FINAL TRIBAL ENVIRONMENTAL IMPACT REPORT

**GRATON RESORT & CASINO EXPANSION PROJECT**

**MAY 2023**

Federated Indians of Graton Rancheria  
6400 Redwood Drive, Suite 300  
Rohnert Park, CA 94928  
(707) 566-2288  
[www.gratonteir.com](http://www.gratonteir.com)

**FIGURE 5 | PROJECT AM(PM) PEAK HOUR TRIPS**  
TRAFFIC IMPACT STUDY

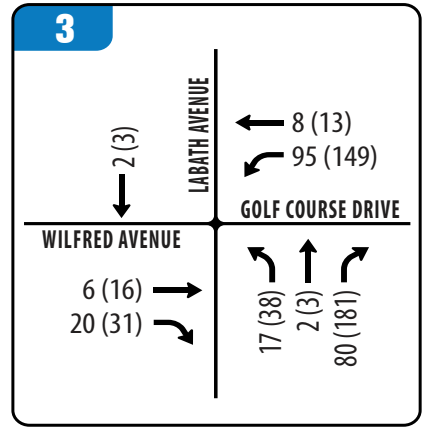
Figure 5 of the TIS shows no project-related traffic making westbound left-turns or northbound right-turns at the Golf Course Drive West/Redwood Drive intersection, but review of the LOS calculation sheets indicates that some traffic is being assigned to these movements. Traffic growth on these movements would be expected since some drivers traveling to and from the casino resort are likely to access the site via existing intersections on Business Park Drive.

The commenter discusses Figure 5 of the TIS, which displays no project-related traffic making westbound left-turns or northbound right turns at the intersection of Golf Course Drive West/Redwood Drive. However, the LOS calculation sheets indicate some traffic was assigned to those movements.

Figure 5 of Appendix G of the Final TEIR has been revised to include westbound left turns and right turns
